CASE #PL2021-42

WALSER TOYOTA BLOOMINGTON, MN

Reviewed for Code Compliance
Date: 11/04/2022
By: K. Bayer
Plan # PRBD202210606

2022 NEW BUILDING FOR:
WALSER TOYOTA
4401 AMERICAN BLVD
BLOOMINGTON, MINNESOTA

ENTRY PORTAL ELEMENT- DESIGNED BY OTHERS
SEE 2/A/3.2 FOR BLDG ELEVATION DESIGN ENTRY PORTAL ELEMENT

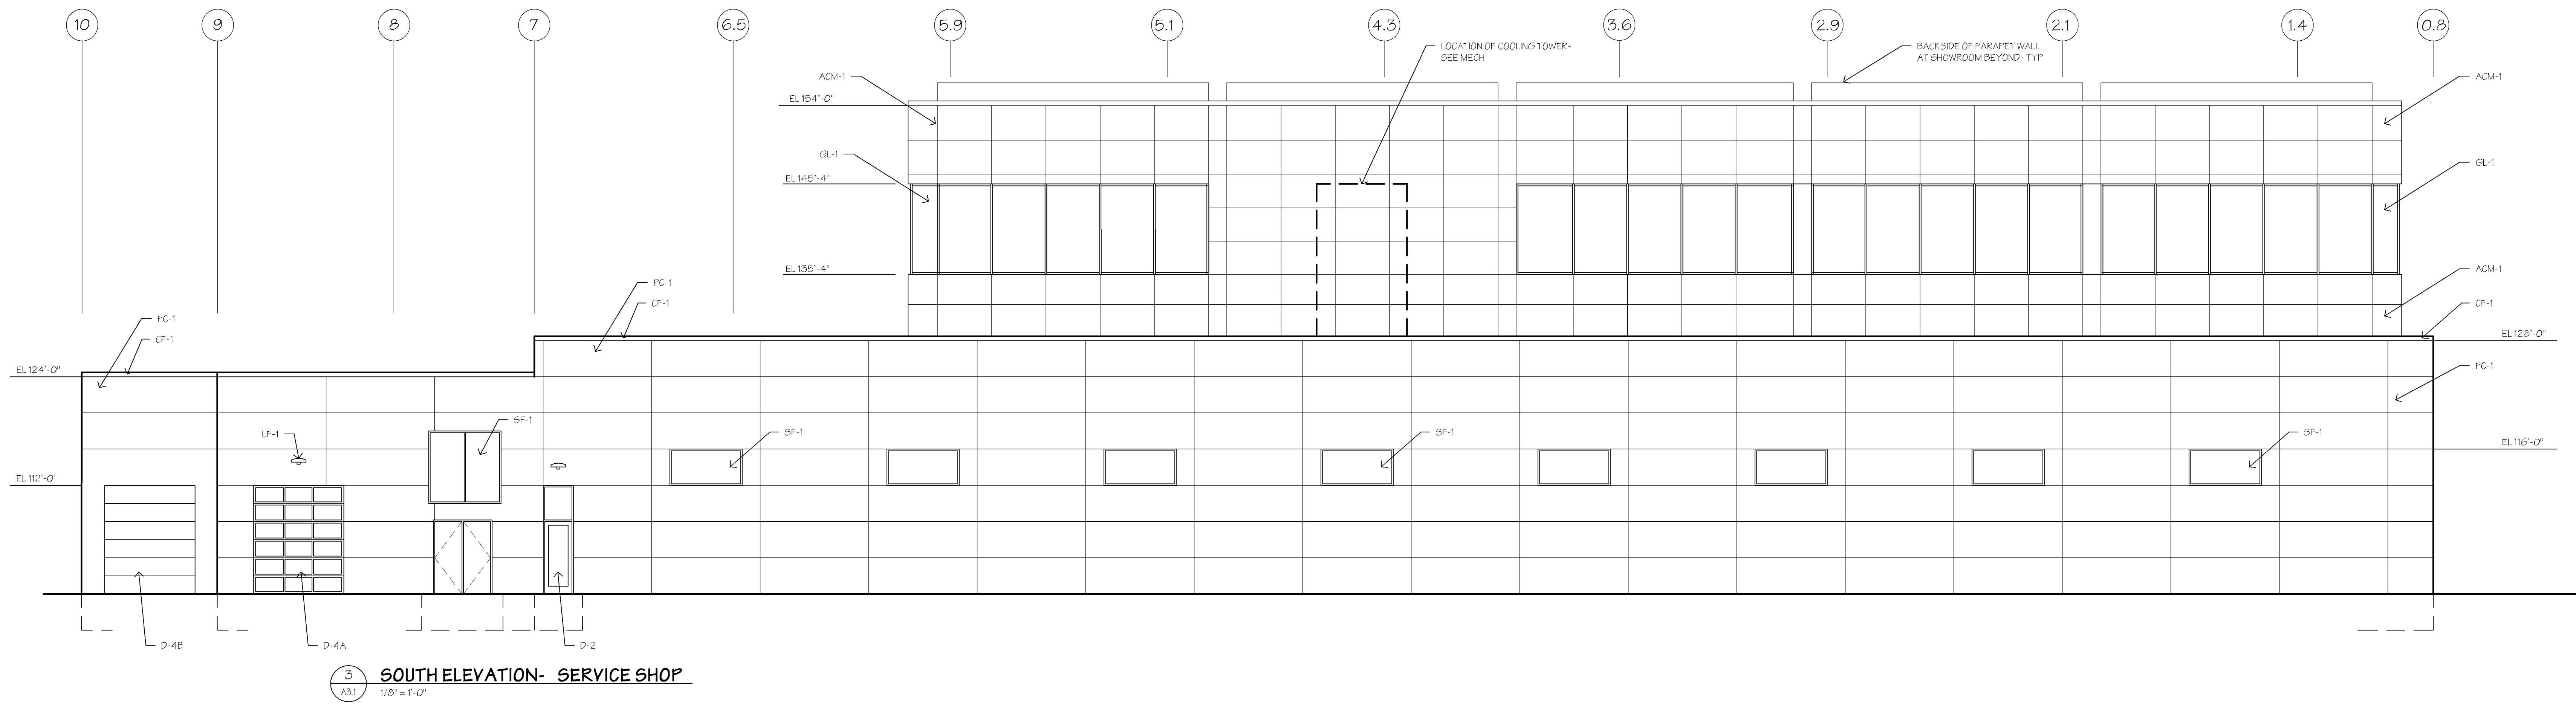
City of Bloomington Planning Division shall approve all wall signs.

Structural Engineer drawings required for any wall signs over 100 square feet.

1 NORTH ELEVATION
1/8" = 1'-0"

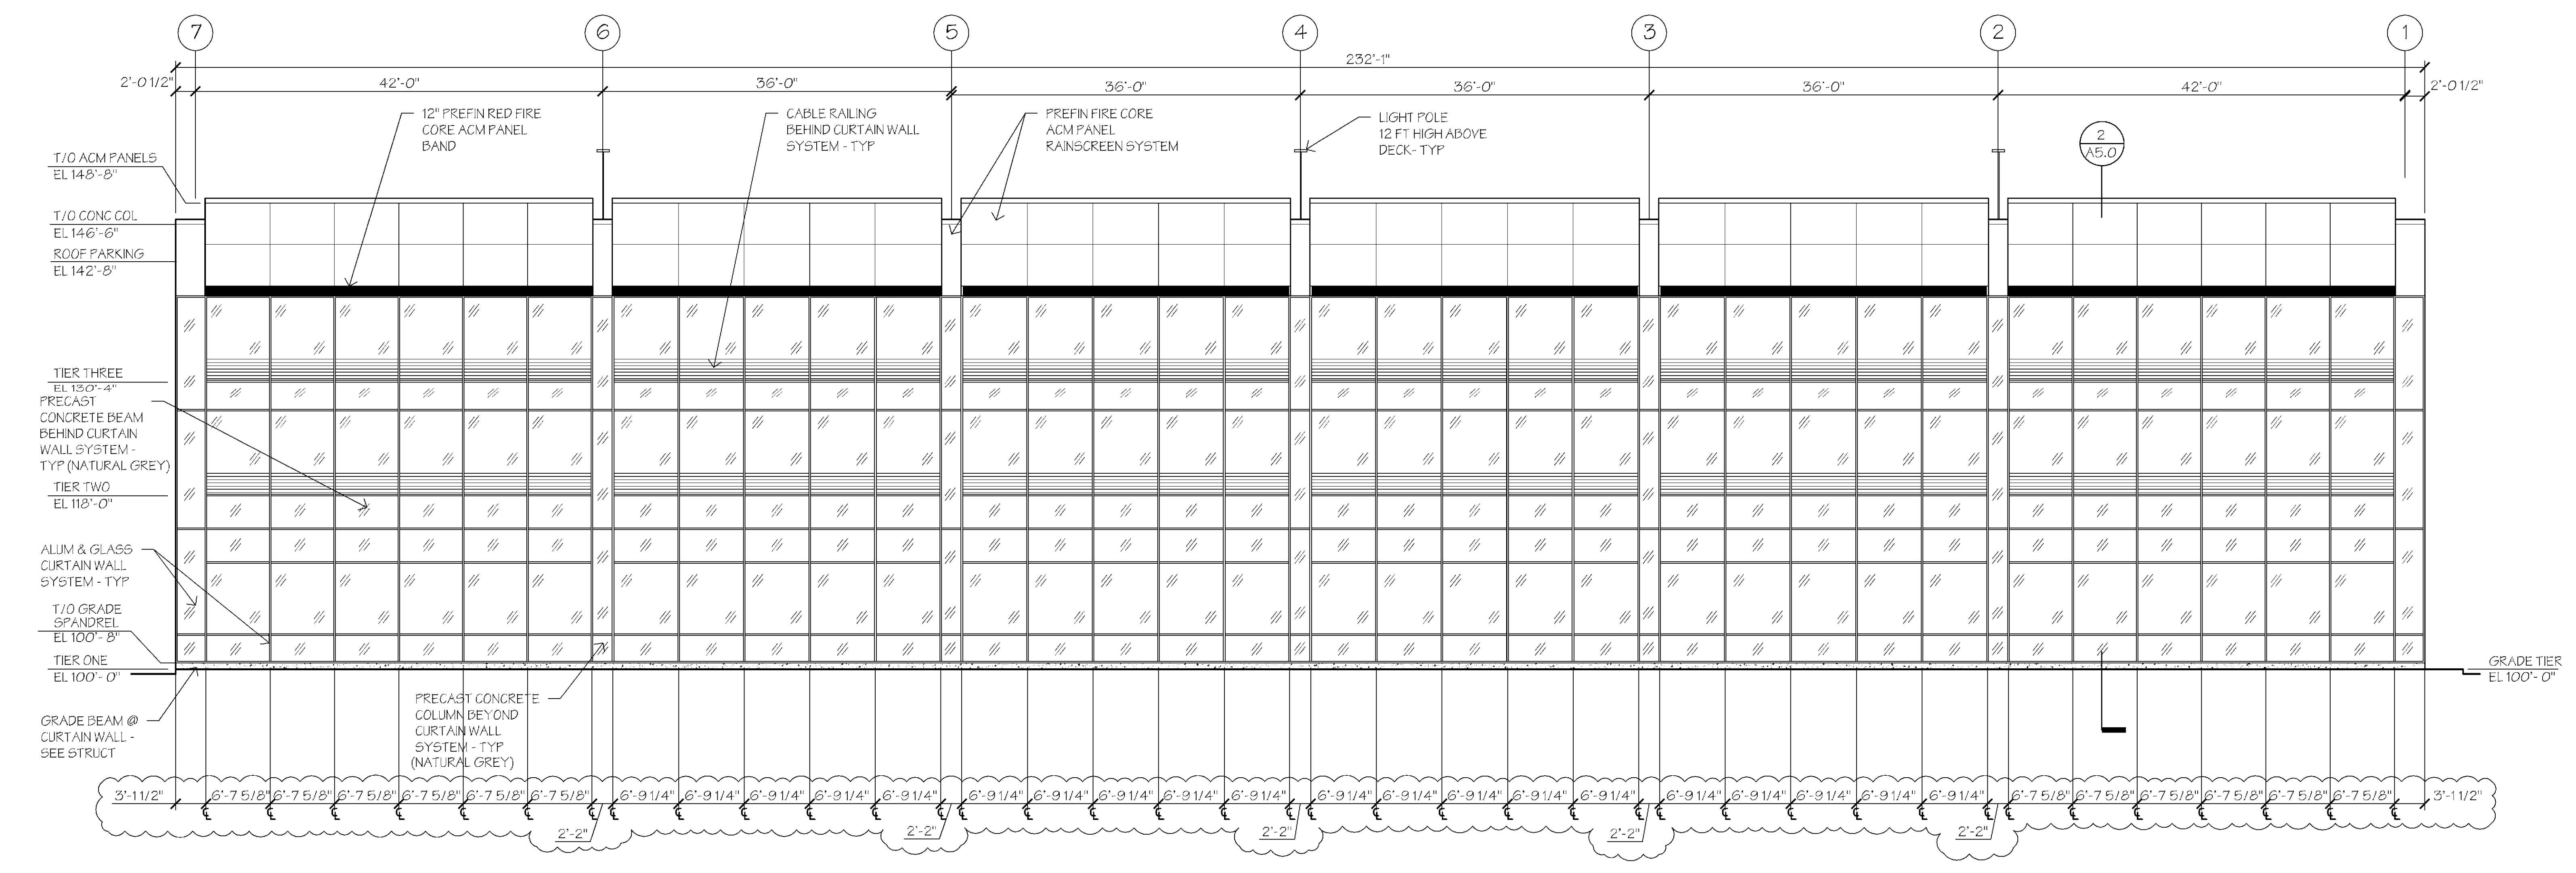
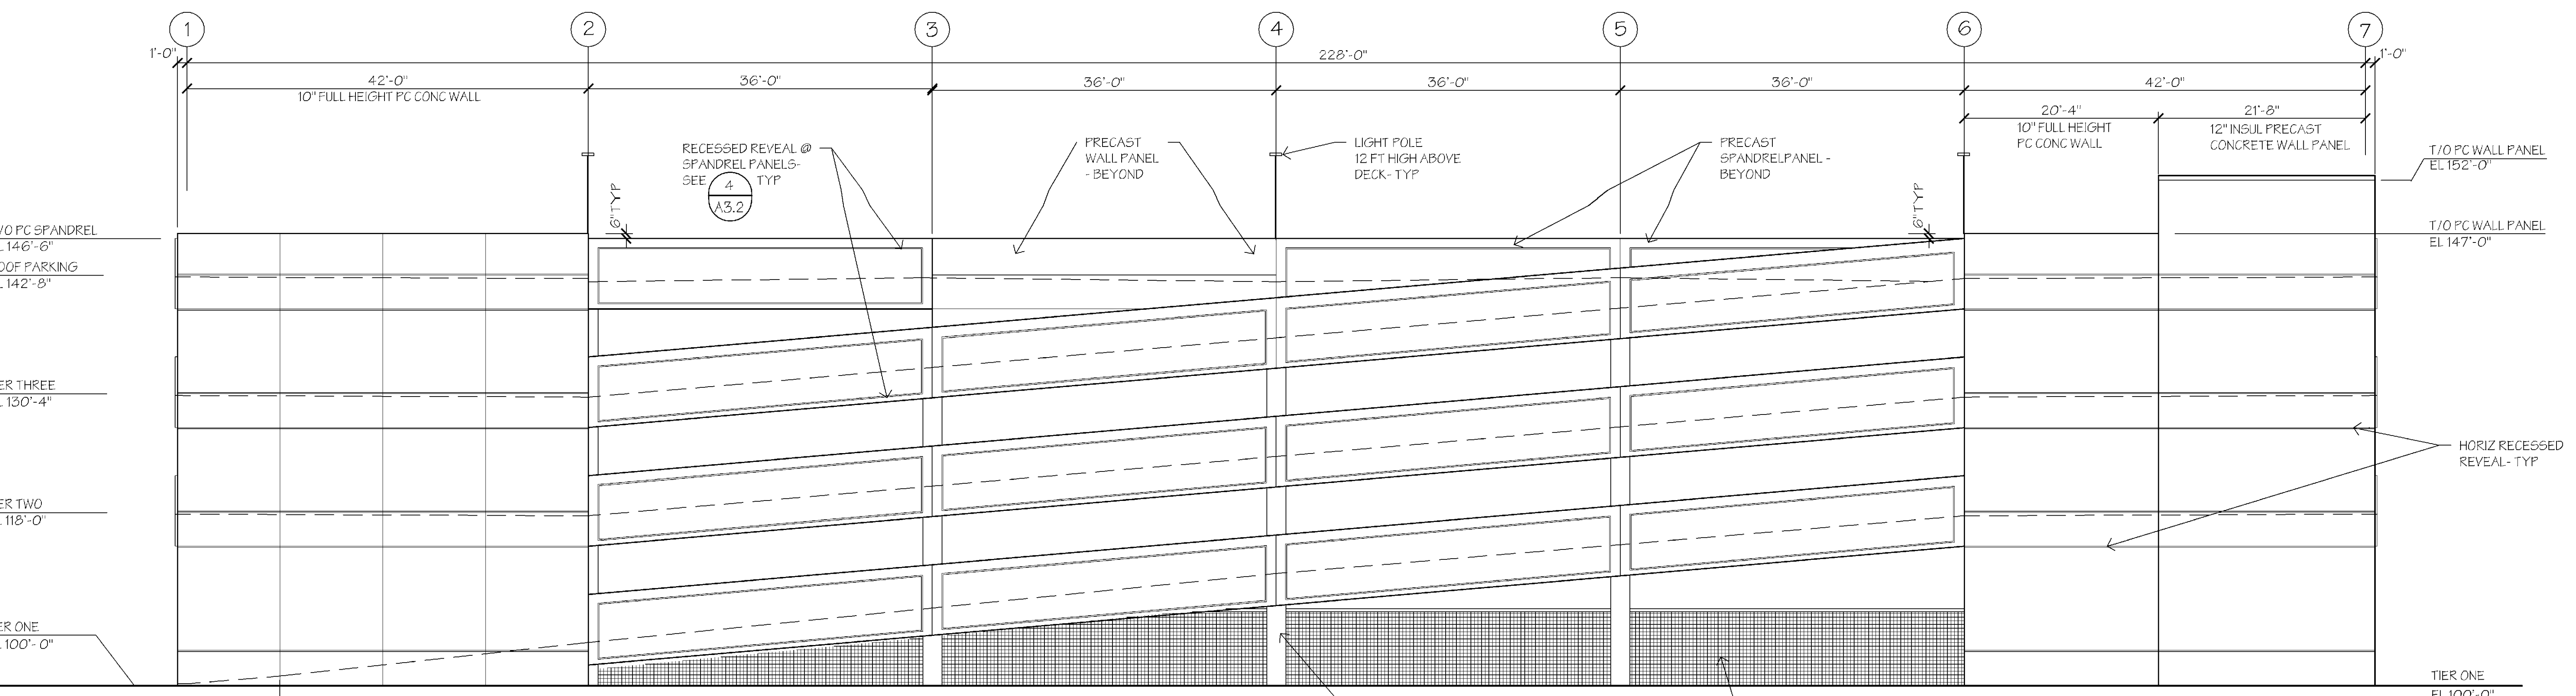
Per 502.6 of 2020 MN Accessibility Code:
A vertical clearance of 98 inches minimum shall be provided at the following locations:
1. Parking spaces for vans.
2. The access aisles serving parking spaces for vans.
3. The vehicular routes serving parking spaces for vans.
